**Florida
Power**
CORPORATION

October 29, 1982
#3F-1082-32
File: 3-F-2

Subject: Crystal River Unit 3
Docket No. 50-302
Operating License No. DPR-72
Generic Letter 81-12 on Fire Protection

FIGURE 2

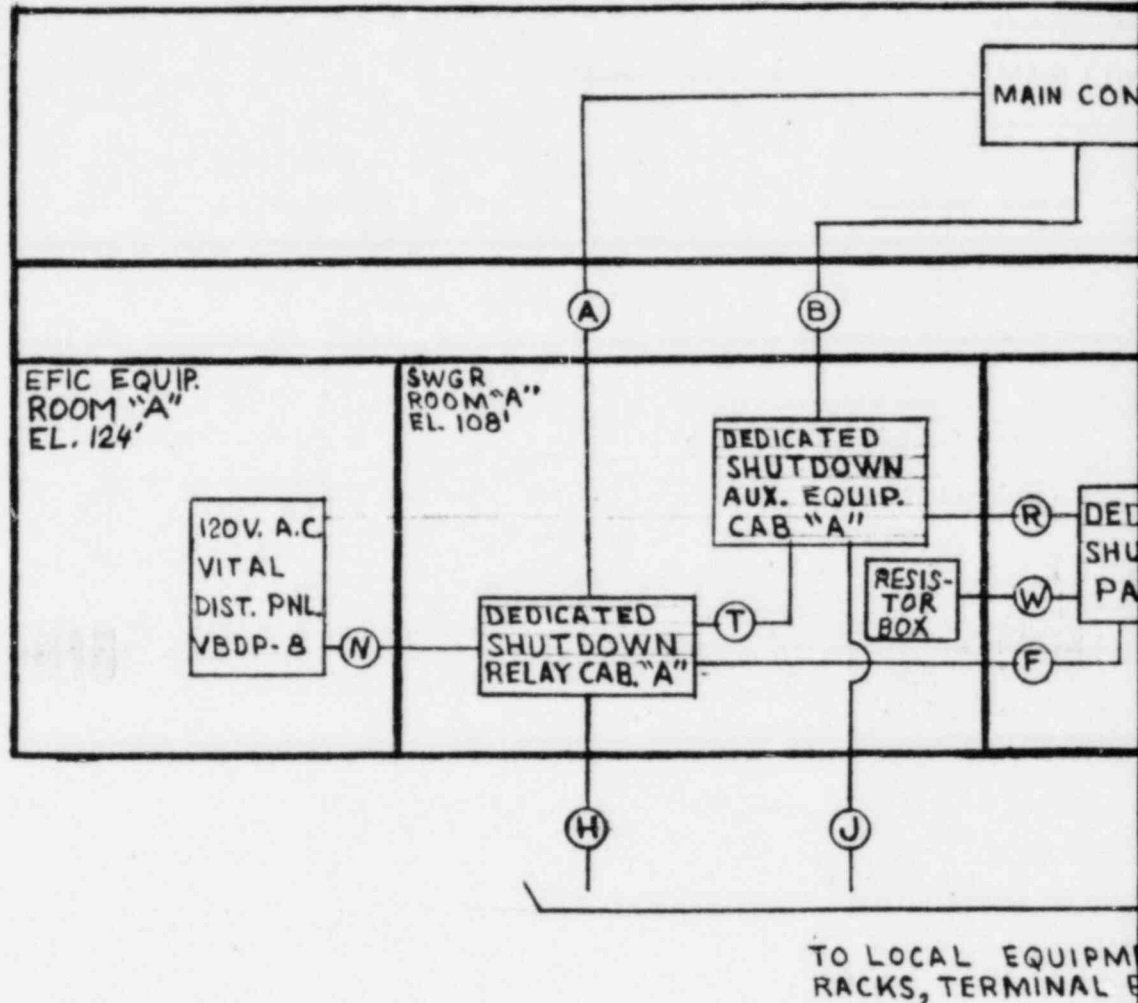
The column labeled "Fire Areas Where Ckt. Is Located" indicates a letter designation which correlates with a letter shown on the block diagram of Figure 2 which schematically shows the routing of the new circuits. Figure 3 shows the layout of the dedicated shutdown equipment.

- 1) The P&IDs, Elementary Drawings, and Block Diagrams are attached. The Breakers providing power are located in VBDP-8 & 10 as shown on Figure 2 and specific power and central feeds to electrical equipment (Motors, Valves) are from Motor Control Centers and Switchgear. These specific feeds are shown on the elementaries. The isolation devices for the control and instrumentation devices are located in the Dedicated Shutdown Auxiliary Equipment Cabinets "A" and "B", the Dedicated Shutdown Relay Cabinet "A" and "B", and the Resistor Boxes. The location of these cabinets is shown on Figure 2.
- 2) The isolation devices provided in the DSP for interfacing with existing equipment are Foxboro Spec. 200 equipment. Environmentally and seismically qualified Model No. N2A0-V2I (V/V option) are utilized. Foxboro product literature showing descriptive information is attached for your information.

Item 1.c requests a listing of the cables in the fire area that share a common enclosure with circuits of the alternative or dedicated shutdown systems. Figure 2 is a block diagram of the dedicated shutdown system. The circuits for the dedicated shutdown system are the cables connected between the Dedicated Shutdown Panel, Dedicated Shutdown Relay Cabinets, Dedicated Shutdown Auxiliary Equipment Cabinets, Resistor Boxes and the 120VAC Vital Distribution Panels.

FIGURE 3, SH. 1 OF 2

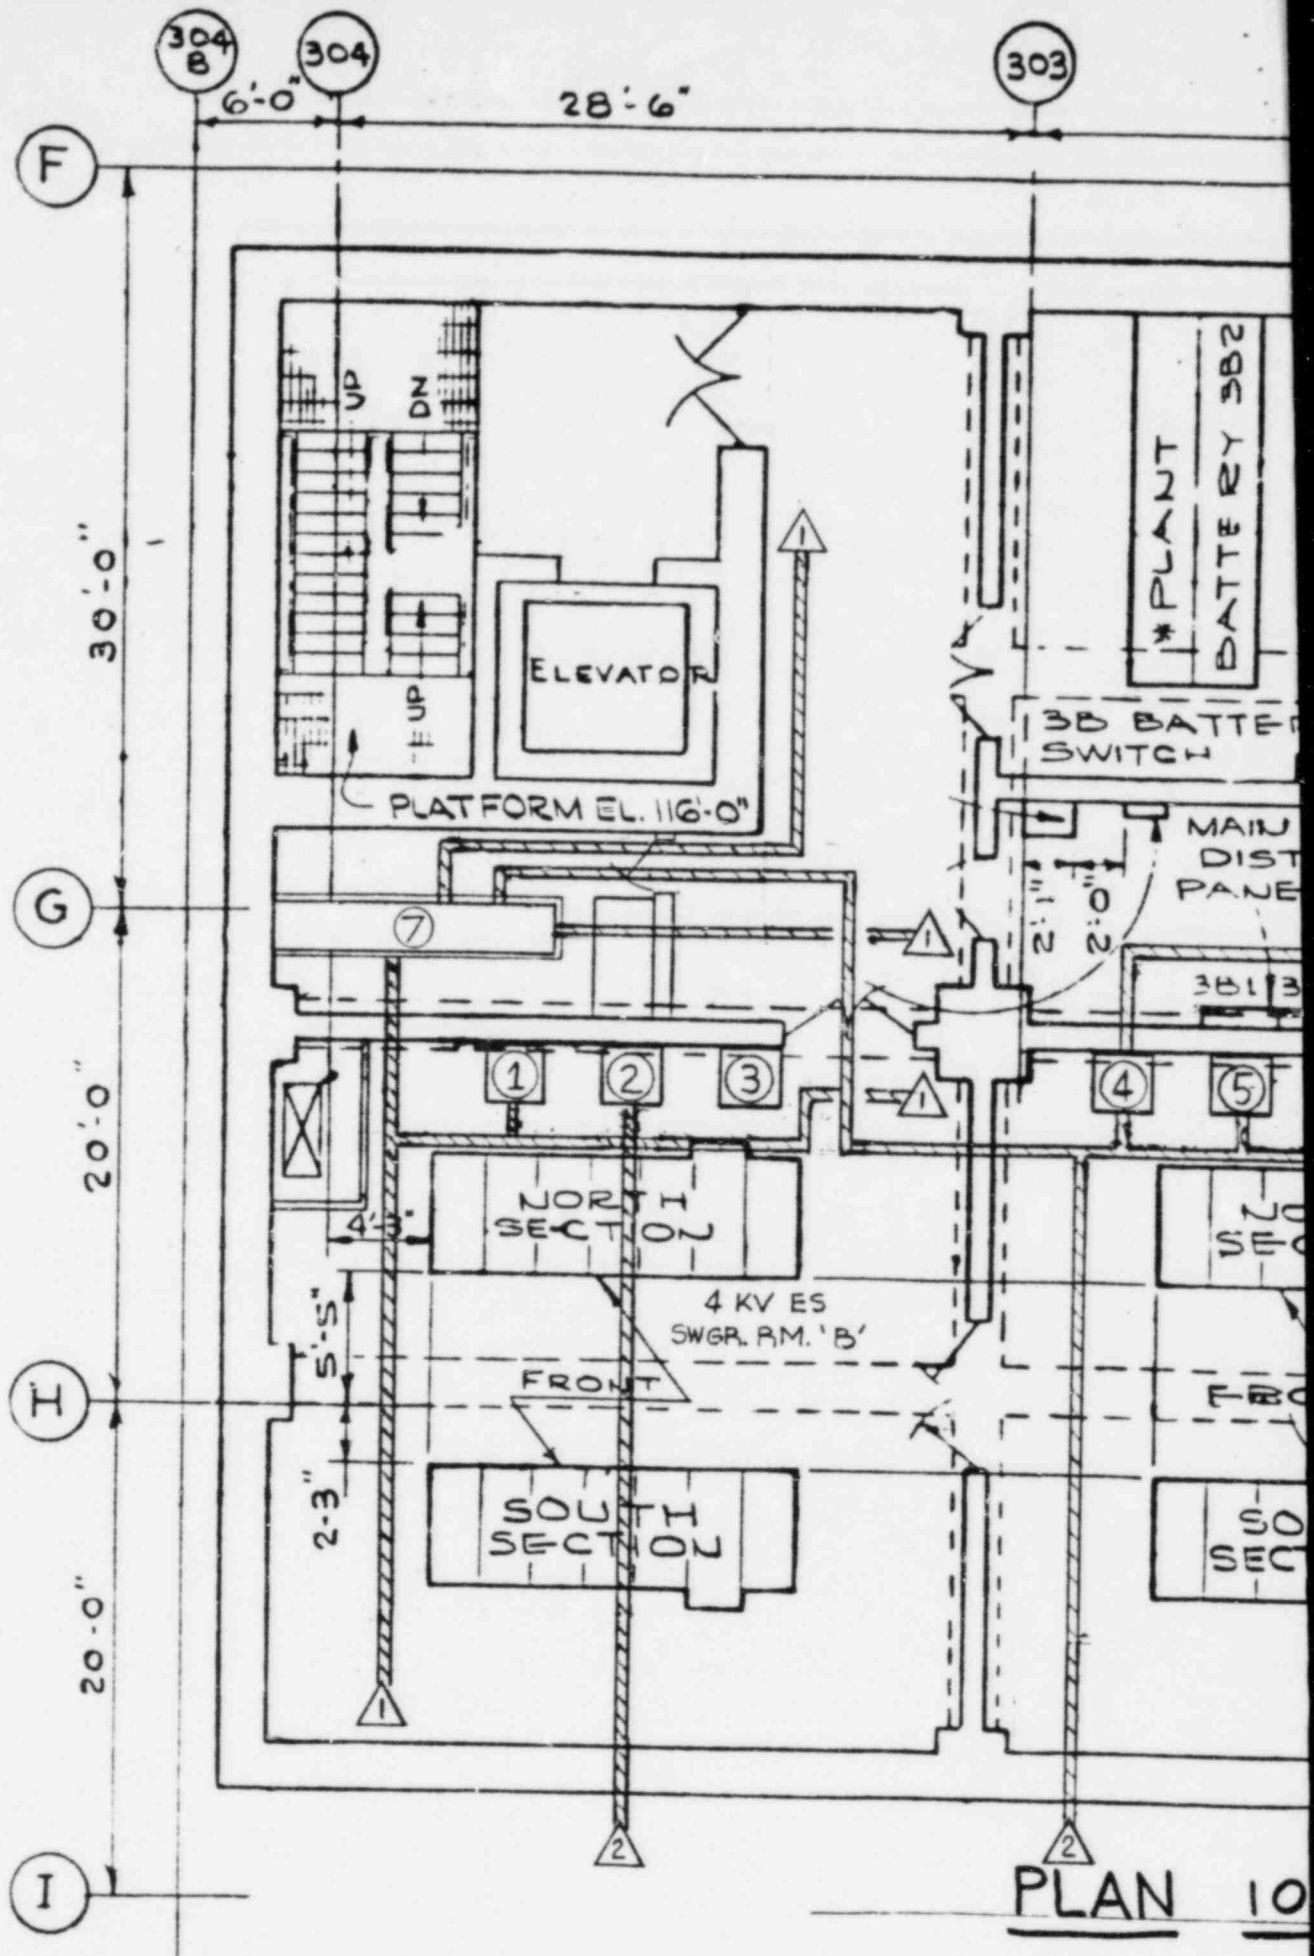
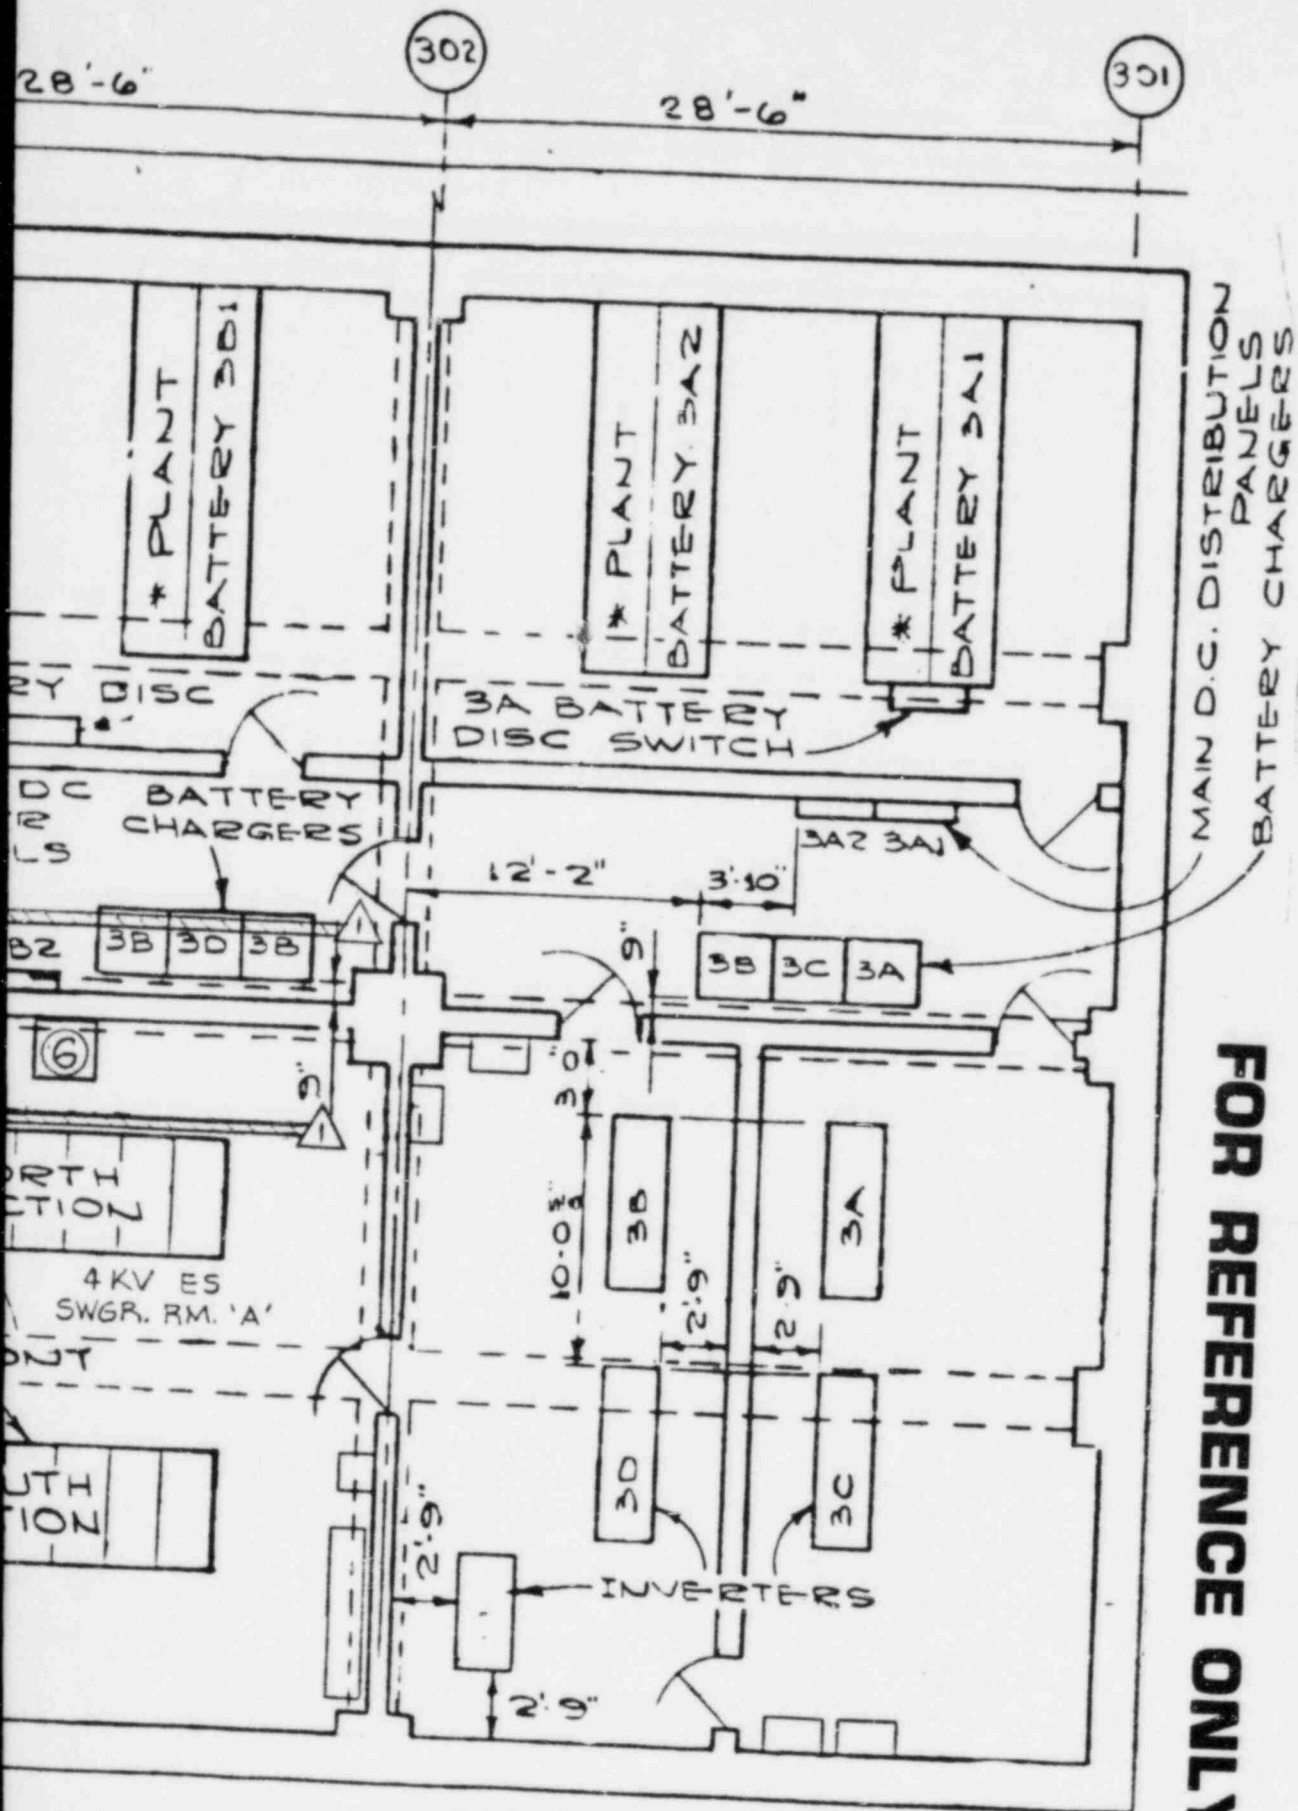
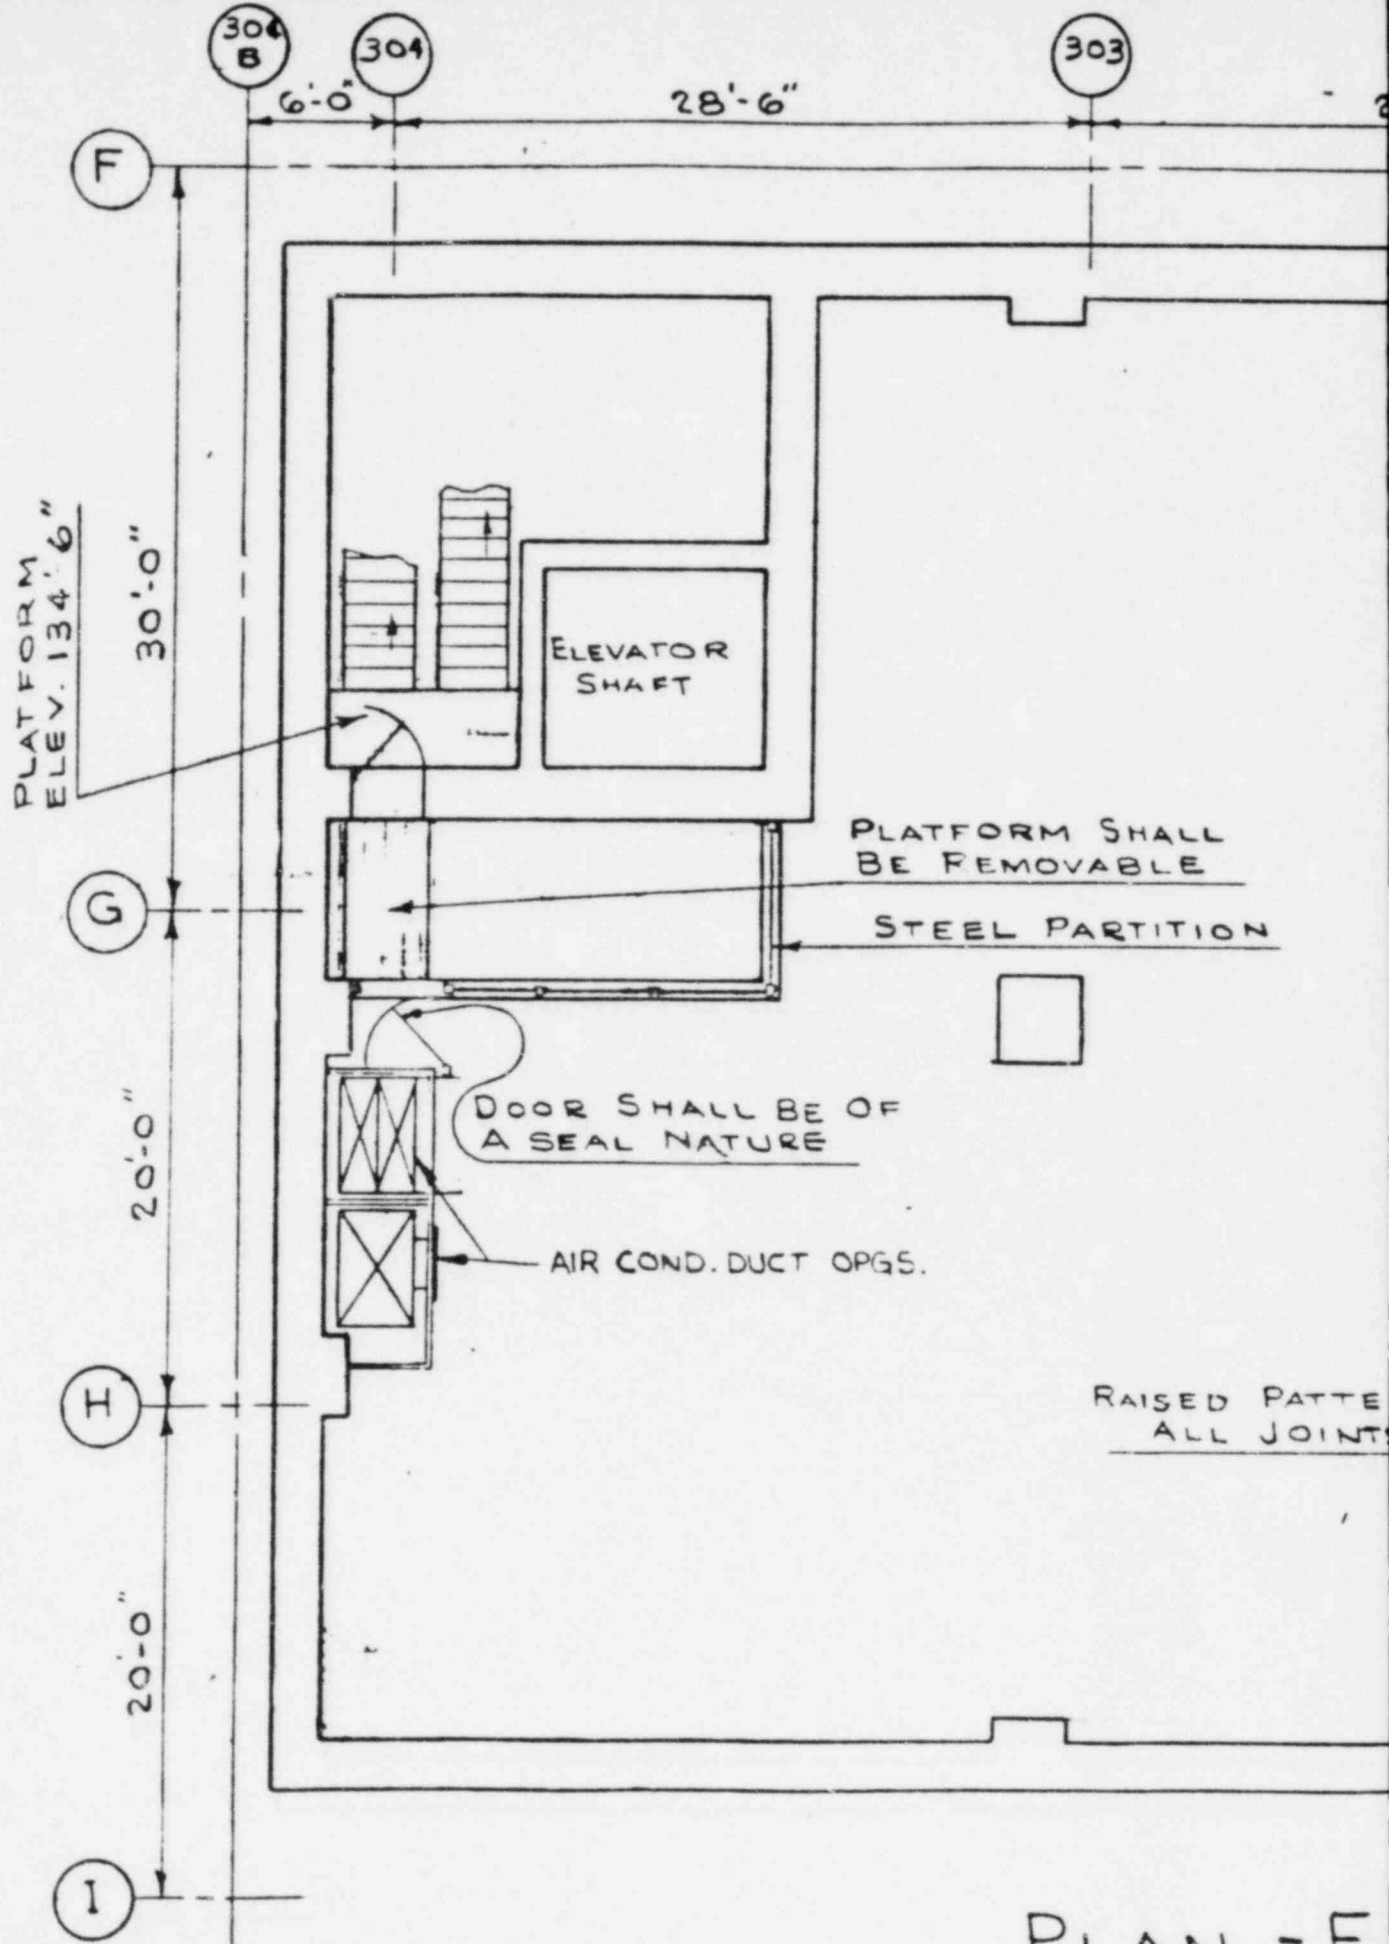
Figures 3 and 6 show the actual location of the dedicated shutdown components and the approximate routing of the circuits. Figures 4 and 5 show the cable spreading room and main control room fire areas. Figures 3, 4, 5, and 6 also verify that no dedicated shutdown components and circuits are located in either the main control room or cable spreading room.
